SERVICE BULLETIN

Classification: EM21-002 Reference:

FUEL AND/OR OIL SMELL IS PRESENT WHEN THE VEHICLE IS PARKED IN A CLOSED GARAGE

2019-2021 QX50 (J55)

Figure 1

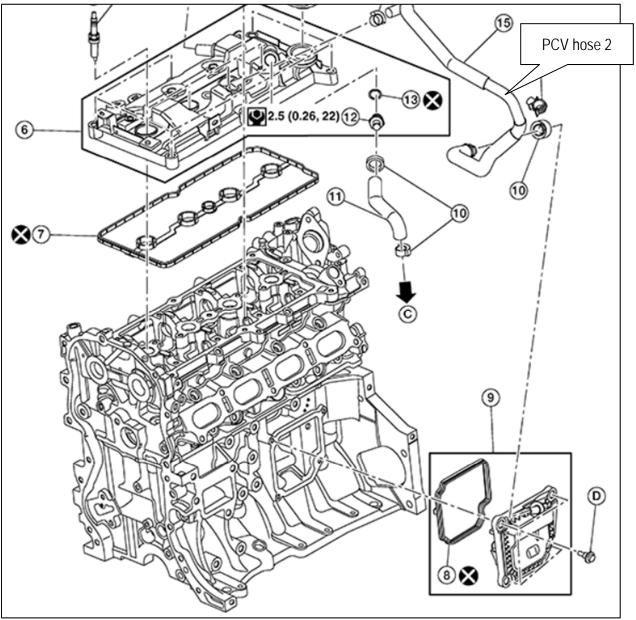
Replace the rocker cover assembly and the PCV separator with those listed in the **PARTS INFORMATION**, and eliminate PCV hose 2.

NOTE: PCV hose 2 (number 15 in Figure 1 on page 2) is no longer required with the parts listed in the **PARTS NFORMATION**.

- 1. Replace the rocker cover assembly (number 6 in Figure 1) with the one listed in the **PARTS INFORMATION**.
 - Refer to the ESM, section ENGINE > ENGINE MECHANICAL > KR20DDET REMOVAL AND INSTALLATION > ROCKER COVER
- 2. Replace PCV separator (number 9 in Figure 1) with the one listed in the **PARTS INFORMATION**.
 - Refer to the ESM, section ENGINE > ENGINE MECHANICAL > KR20DDET > REMOVAL AND INSTALLATION > PCV SEPARATOR

NOTE: PCV hose 2 (number 15 in Figure 1) is no longer required with the parts listed in the **PARTS INFORMATION**.
